K95KNGP800C Class II Permissive Change Request – Circuit Change Description

Applicant: RELM Wireless Corporation
FCC ID: K95KNGP800C

Figure 2 – Transmitter with Changes to Support Emissions Designator 8K10F1W

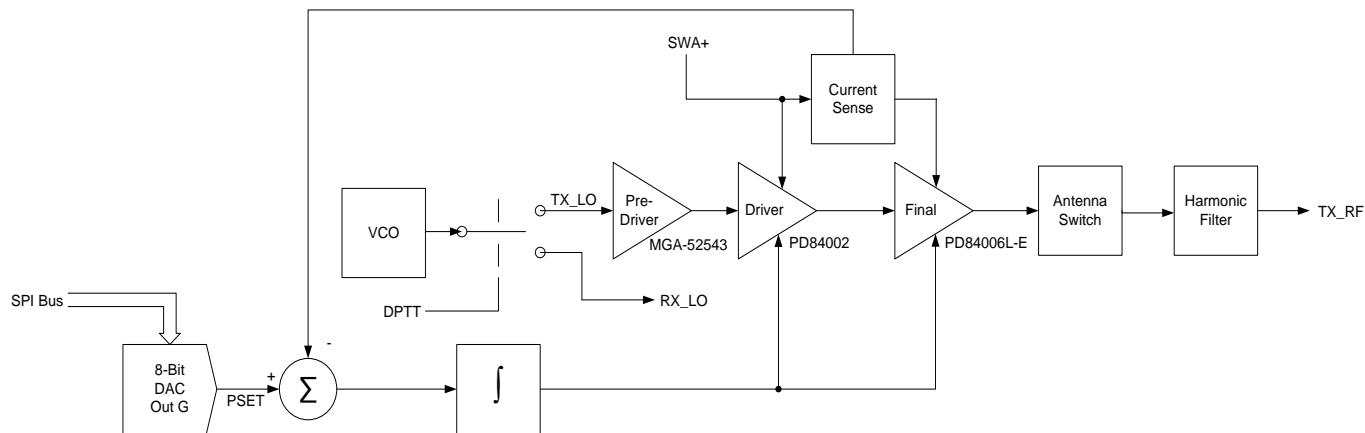
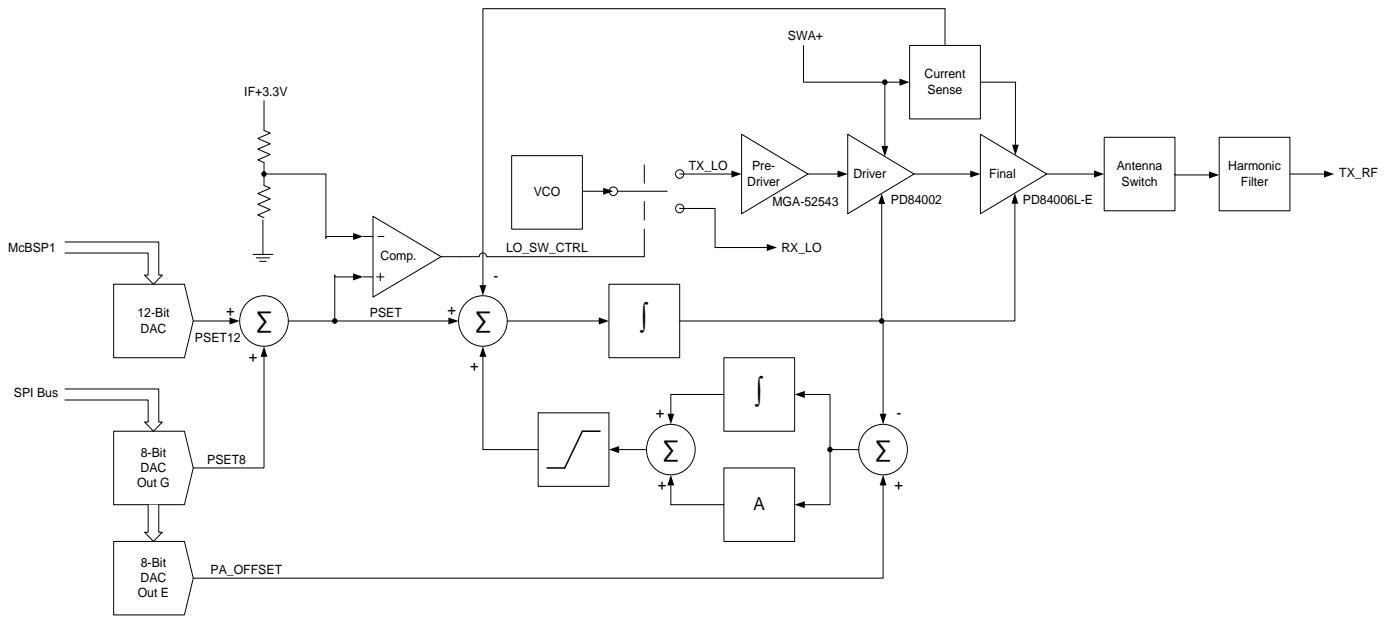
Some changes to the transmitter power control circuitry are required in order to support the more accurate power ramping required for P25 Phase II operation (emissions designator 8K10F1W). These changes consist of: the addition of a 12-bit DAC to set power, the addition of a comparator to control the existing RX/TX LO switch, and the addition of a secondary control loop to maintain a software adjustable offset on the driver and final gate voltages during the off slot. Figure 1 below shows a block diagram of the transmitter as it was when the K95KNGP800C type acceptance was granted and Figure 2 shows a block diagram of the transmitter with the changes required to support emissions designator 8K10F1W. No changes have been made to the synthesizer, VCO, pre-driver stage, driver stage, final stage, antenna switch, or harmonic filter. None of the changes will affect maximum output power.
